DESCRIPTIVE REPORT

Registry Number: **H11079**

Sub-locality: Great Round Shoal

ATLANTIC HYDROGRAPHIC BRANCH EVALUATION REPORT FOR H11079 (2004)

Figure 2: Bottom change on crest of sandwave over period of 21 days.

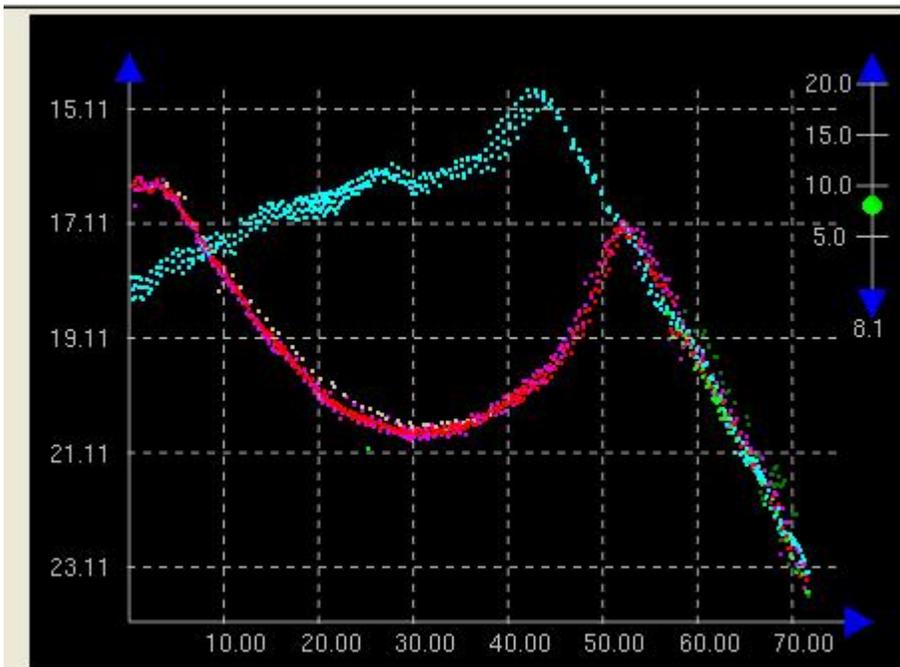
MBES data were acquired over a period of 38 days. During this time there was very obvious movement of the sandwaves, horizontally and vertically (see figure 2). This survey is being submitted now rather than continuing acquisition next year due to this rapid bottom change in the survey area. Poor weather conditions caused the premature end of acquisition for the year. One area in the Eastern part of the sheet has minor gaps in MBES coverage. This MBES data gap overlaps the area of 100% SSS coverage. The hydrographer recommends updating the nautical charts based on the available data. ***Concur.***

3) The Great Round Shoal is a natural feature that changes frequently and rapidly. Observations from the field unit show that the shape and least depth of this shoal changed dramatically over a 21 day period (H11079 Descriptive Report, Pg 4, Figure 2). It is recommended to add a note to the chart alerting the mariner of the dynamic seafloor condition which is subject to continual change. Defer final charting recommendations to Marine Chart Division.

1.5) Profile/Beam - 259/81 from h11079 / 1005_mb / 2004-240 / 670_1605

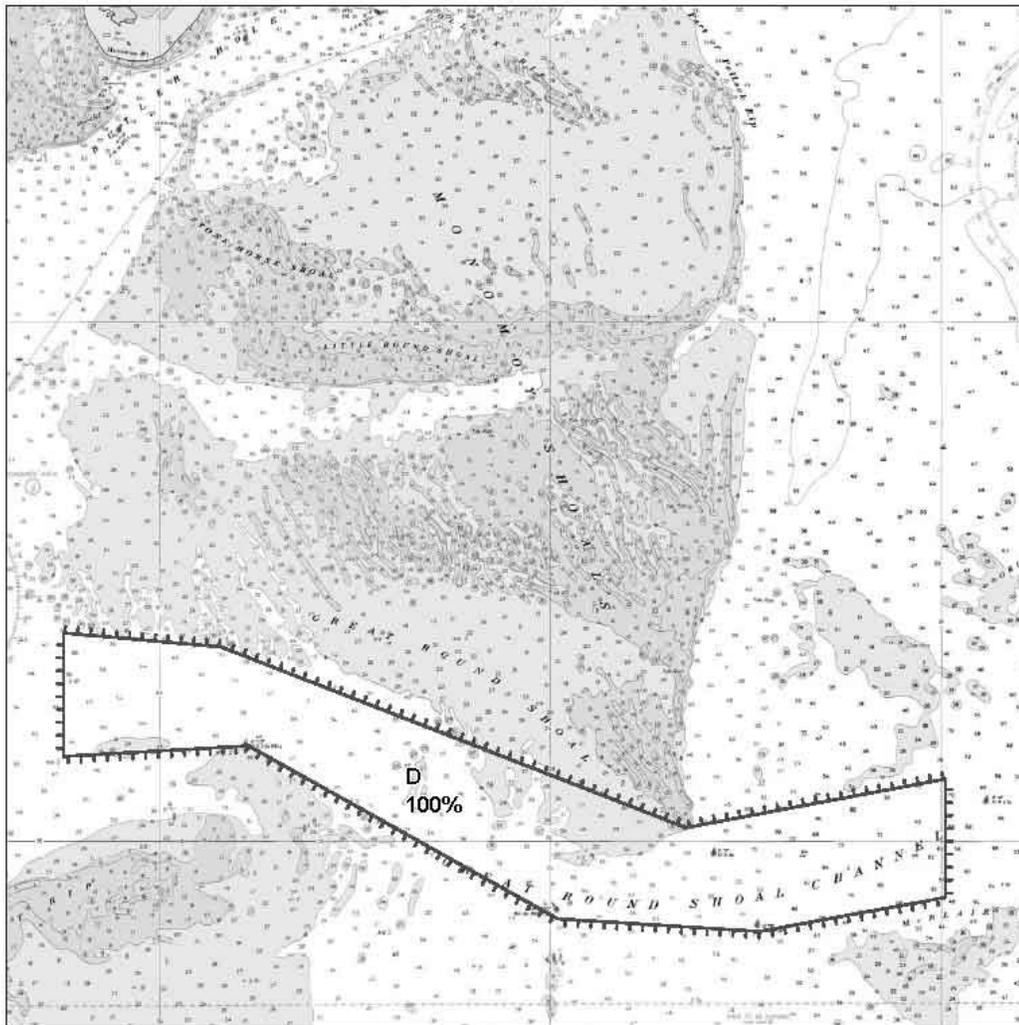
Items identified with 100% SSS and RESON 8101 MBES. Near RW"GRC" buoy (possible buoy block).

Chart per digital data.

Do not concur. Feature is present in SWMB and SSS; it was determined not to be the nearby buoy block. The height of this feature is insignificant compared to the depths within the common area. Chart present survey soundings in the common area.
